YARRA PLANNING SCHEME

SCHEDULE 18 TO CLAUSE 43.02 DESIGN AND DEVELOPMENT OVERLAY

Proposed C273yara

HEIDELBERG ROAD PRECINCTS

Figure 1: Indicative Cross Section and Measurements

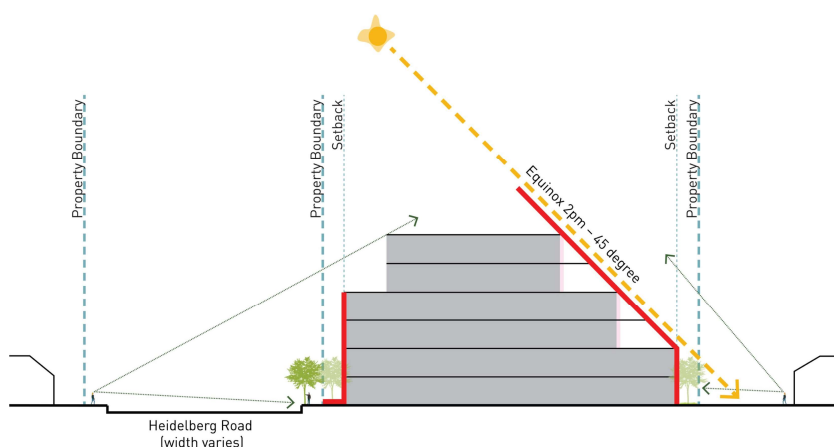
Upper levels above a rear boundary wall must be set back from the rear boundary and be contained within a 45 degree setback envelope. The envelope's angle is to be measured perpendicular to the ~~applicable development site's~~ boundary or setback, taken from the centre of the boundary.

Commented [YCC5]: In response to Submission 31 regarding wording clarification.

Development must provide minimum ~~landscape-ground floor~~ setbacks to the rear boundary as follows:

- Precinct 1: ~~a minimum of~~ 3 metres (as shown on Map 1);
- Precinct 3A: ~~a minimum of~~ 4.5 metres;
- ~~Precinct 2 and Precinct 3B: All other areas: a minimum of 3 metres if the dwelling on the adjacent residential property is located less than 15 metres from the property boundary:~~
 - ~~5 metres where a development site directly abuts a rear boundary of an adjacent residential lot.~~
 - ~~3 metres where a development site directly abuts a side boundary of an adjacent residential lot.~~

Commented [YCC6]: In response to Submission 5, 34, 54 and 117 regarding improving the rear interface controls.

Map 1: Building and Street Wall Heights for Precinct 1

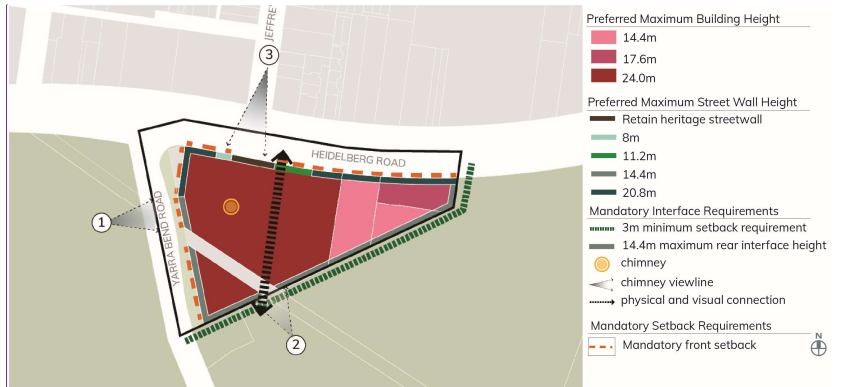
Commented [YCC17]: Officer additions to provide more clarity around the location of the chimney which has been added onto Map 1.
